## 8.0 Roof amendments

**11.3 LB Camden pre-application response letter**

**Re: 13-17 Fitzroy Street, London, W1T 4BQ**

Fig. 8.1 - Roof plan - Overlay consented and proposed plant enclosure

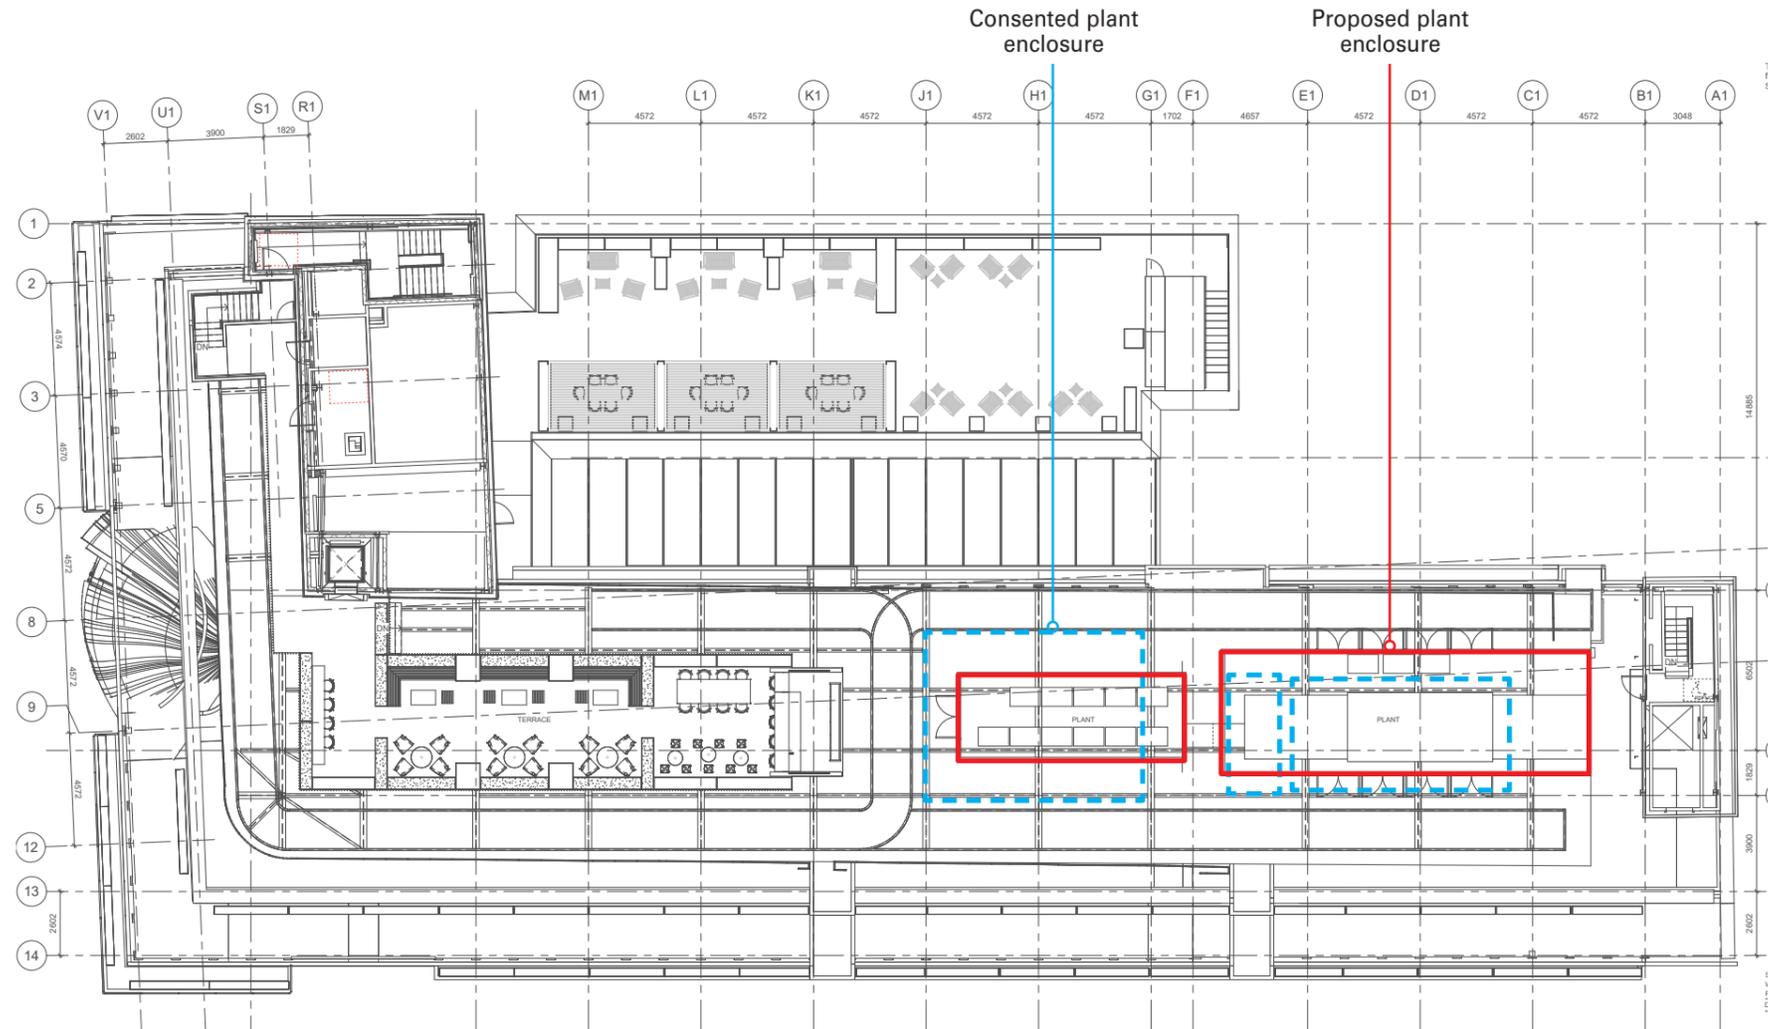
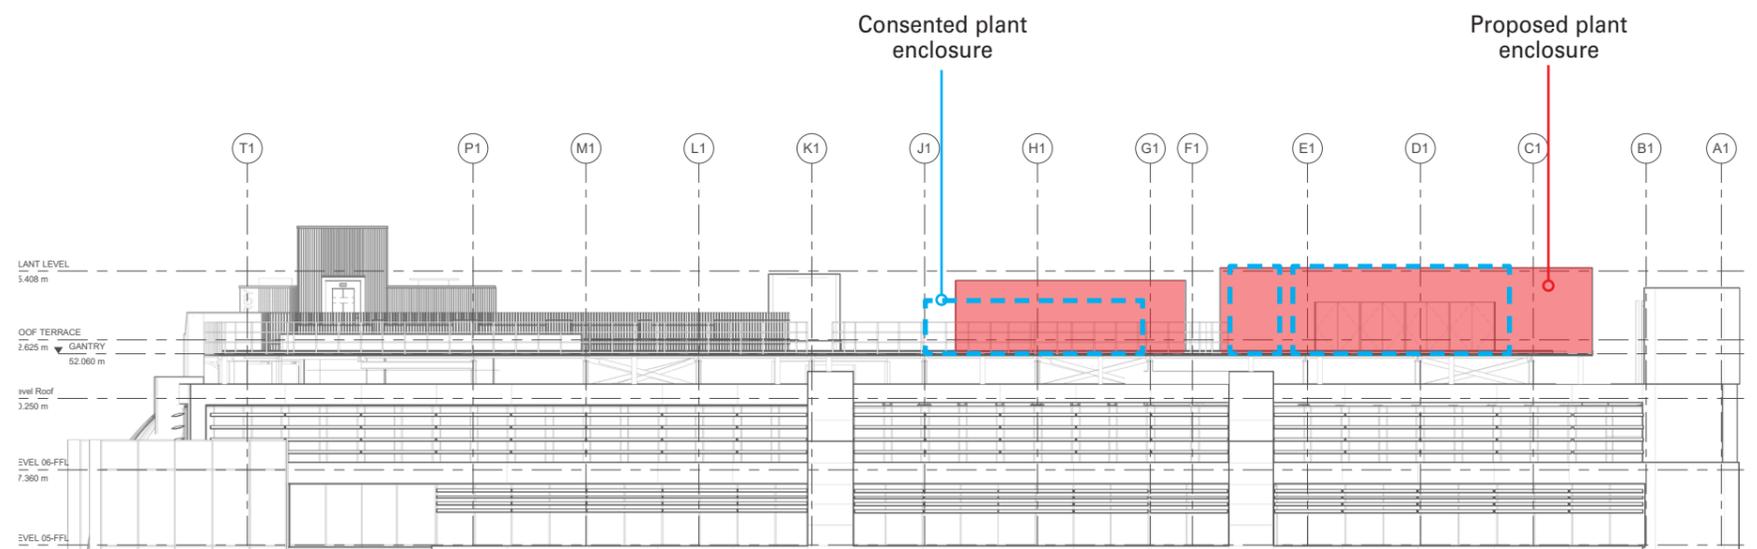
8.1.2 The proposed scheme revises the size of the plant enclosures to follow the size of the revised plant equipment. The smaller plant enclosure will be acoustically treated to prevent noise break-out to the adjacent roof terrace. Both plant enclosures are open air and have louvred walls with louvred access doors.

8.1.3 Fig. 8.1 and 8.2 show overlay of the consented and proposed plant enclosures extent. The existing plant heights have also been dotted on for comparison.

Fig. 8.7 - Proposed Block B Terrace Design Intents

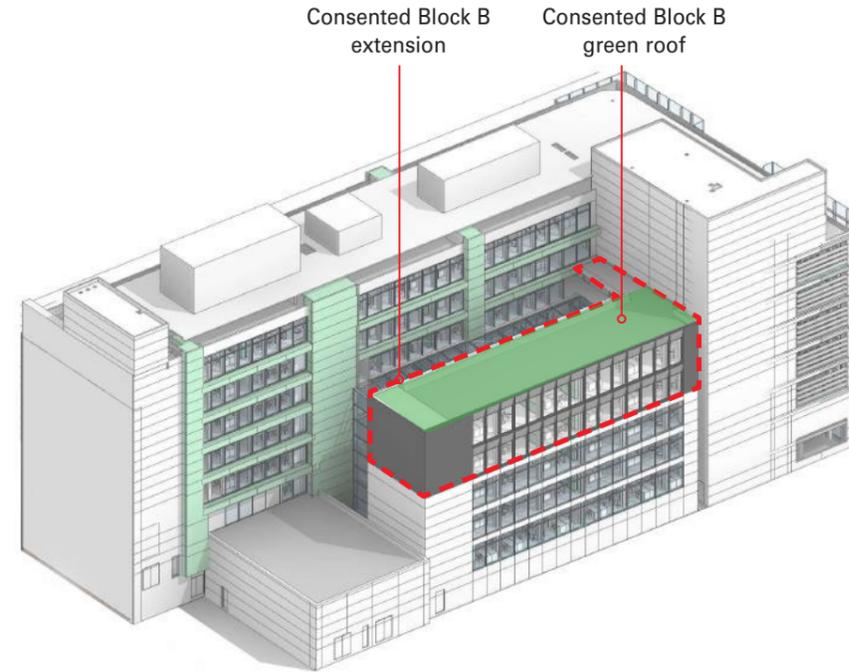
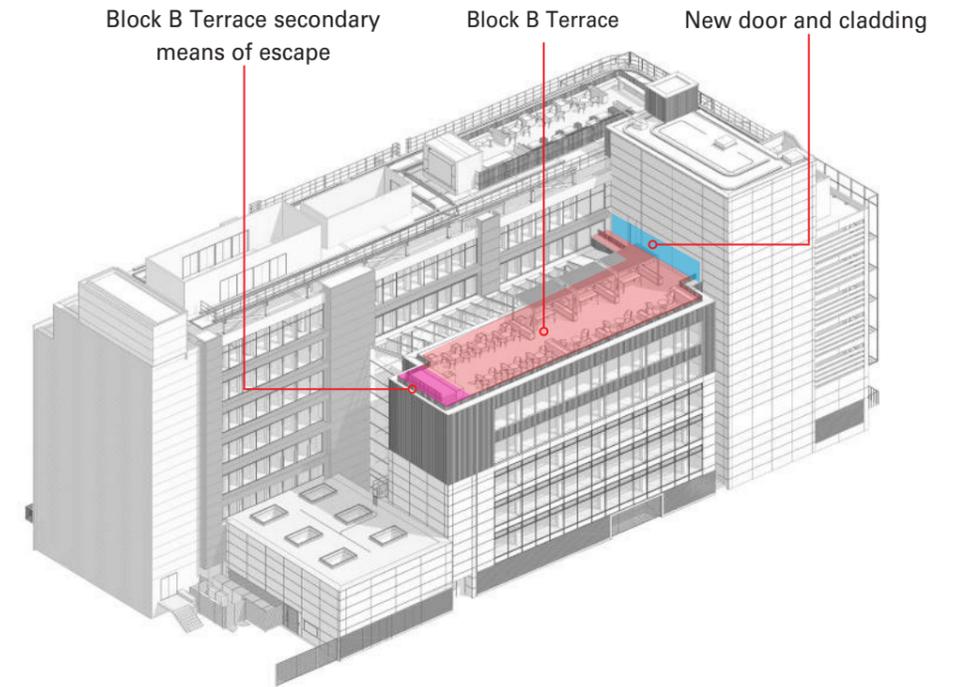
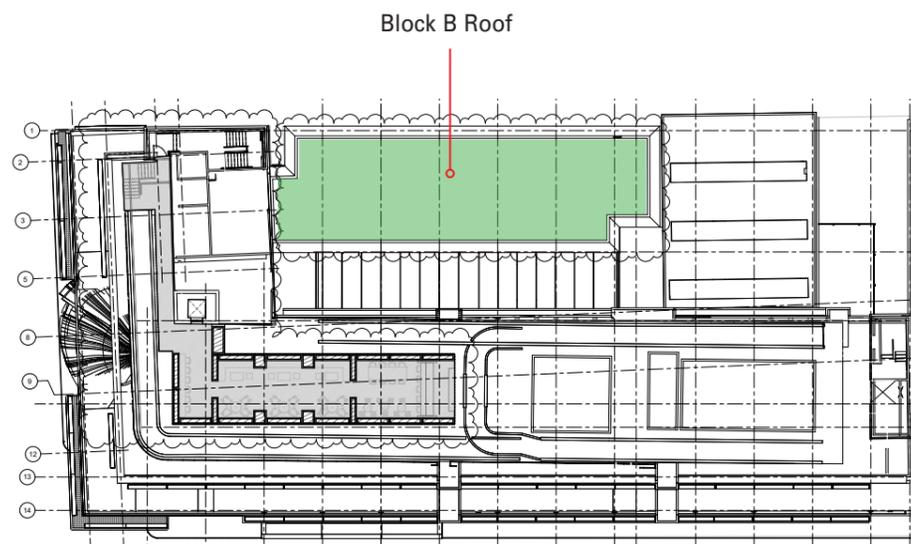
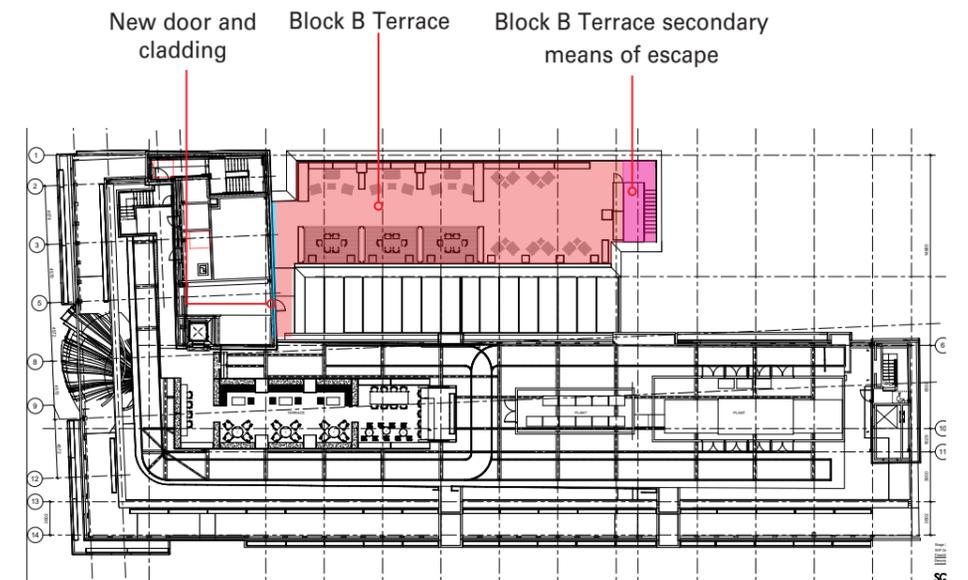
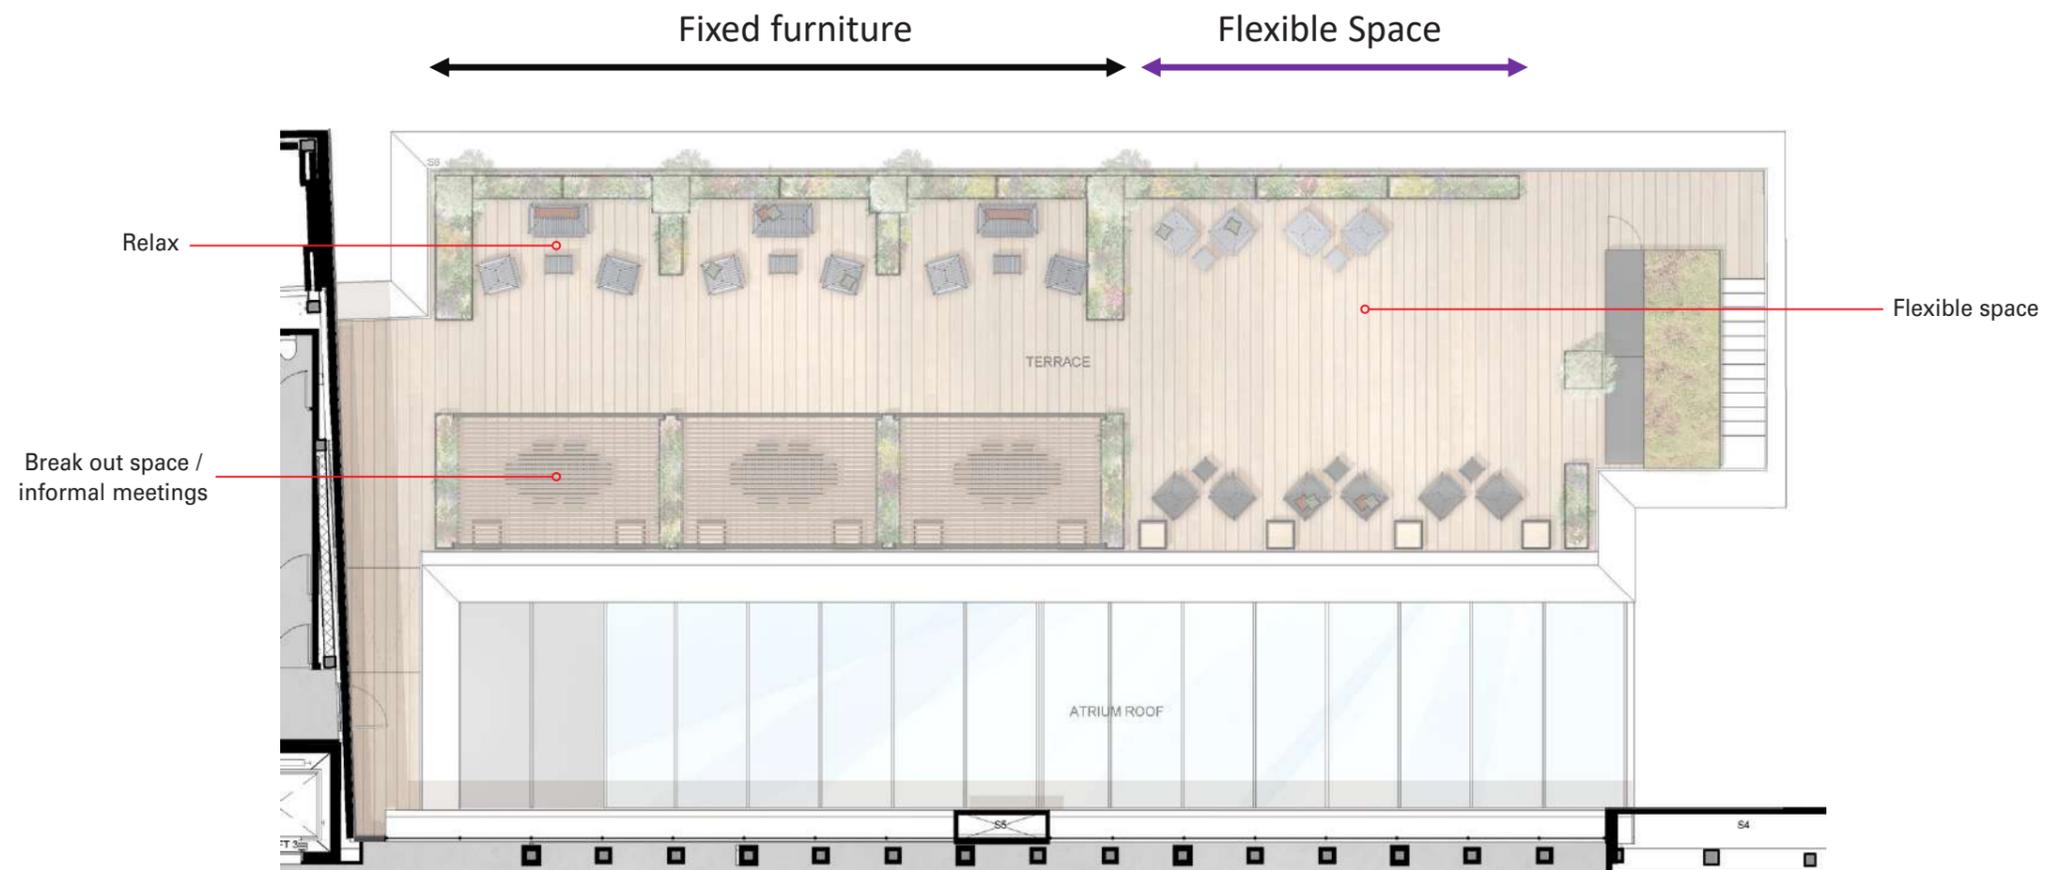
- 8.2.1 The consented scheme has a biodiverse green roof on top of the Block B extension that was not accessible by the office tenants.
- 8.2.2 The proposed design relocates the biodiverse green roof from Block B onto the Block C roof, and introduces a new roof terrace on top of Block B. This roof terrace will be used by the office tenants for informal meetings, as a breakout space or as a wellbeing space.

- 8.2.3 A section of the existing rainscreen cladding to Block A at level 5 will be removed to allow for the introduction of a new external door for access onto the terrace. A new metal panel will replace the existing panels that will be removed.

- 8.2.3 The roof terrace introduces a metal balustrade around the perimeter of the Block B extension. Planters run around the outer edge of the terrace and there are three pergolas next to the atrium roof glazing that will provide shade with hanging and climbing plants. The types of plants that will be used in the planters on the roof terrace are to be confirmed.

- 8.2.4 The plan and the accompanying images (Fig. 8.7) on the following page illustrate the design intent for the roof terrace.

Fig. 8.11 - Proposed Block C Roof Plan

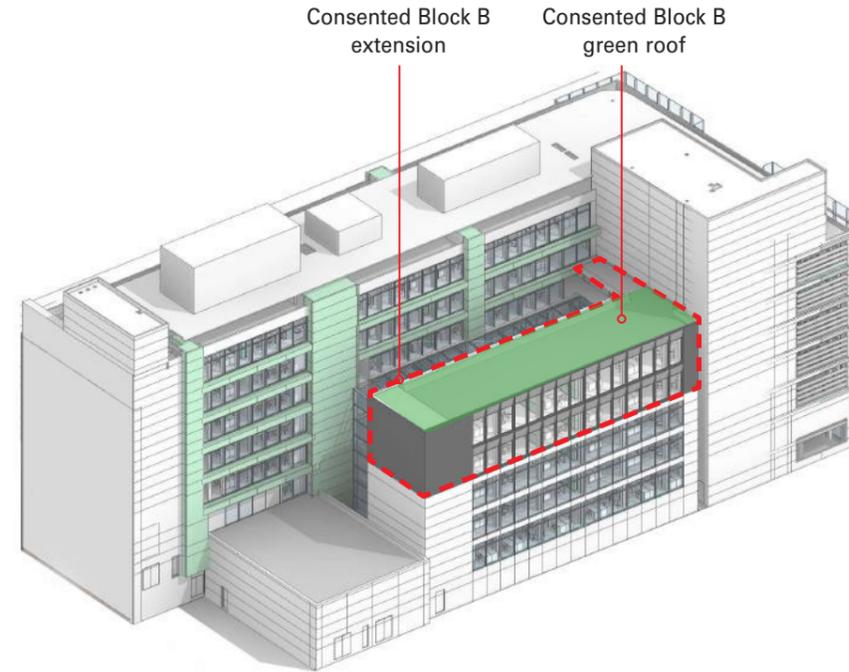
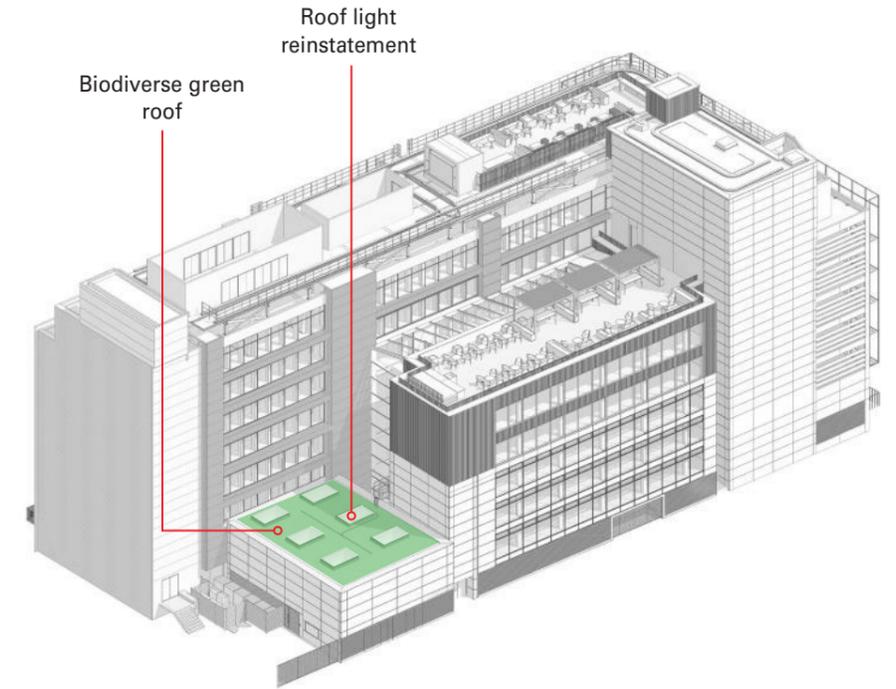
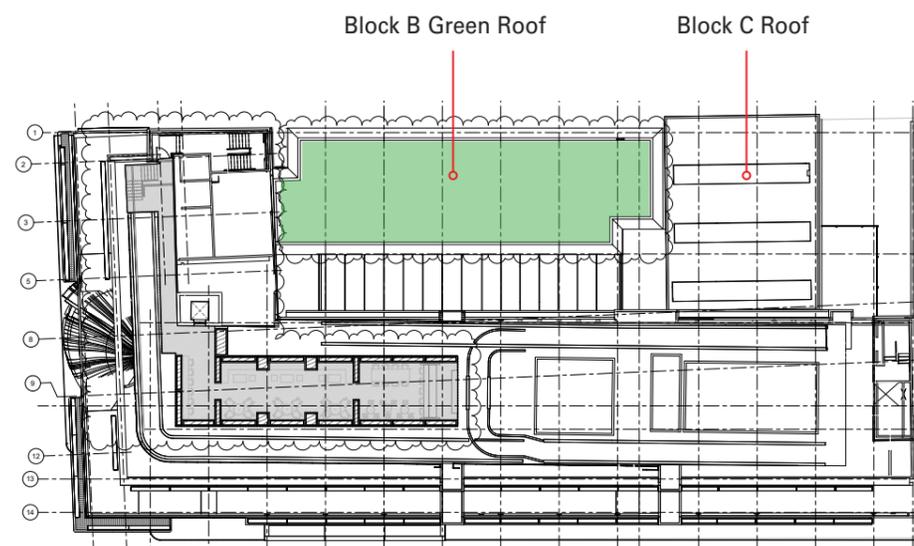
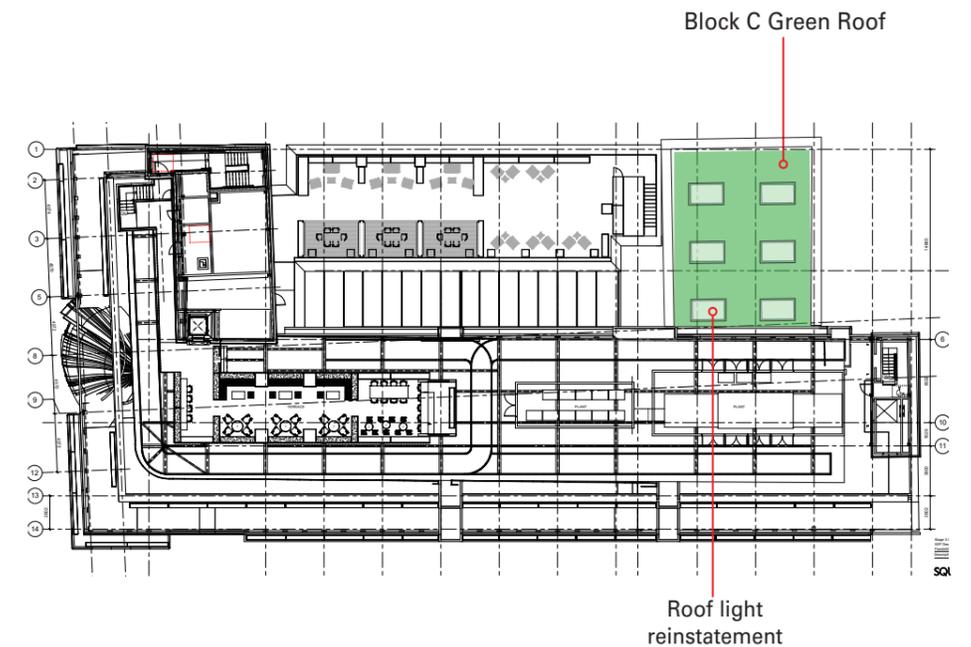
8.3.2 The proposal relocates the biodiverse green roof from the Block B roof onto the Block C roof. Access onto the Block C roof for maintenance of the green roof will be the same as the existing building (access is from an external door in the Core 2 stair that leads onto a metal access platform).

8.3.3 The original Block C design has three long linear roof lights which were filled in during the last building refurbishment. We propose to reinstate six roof lights on the Block C roof to provide natural light into the office unit at ground floor.
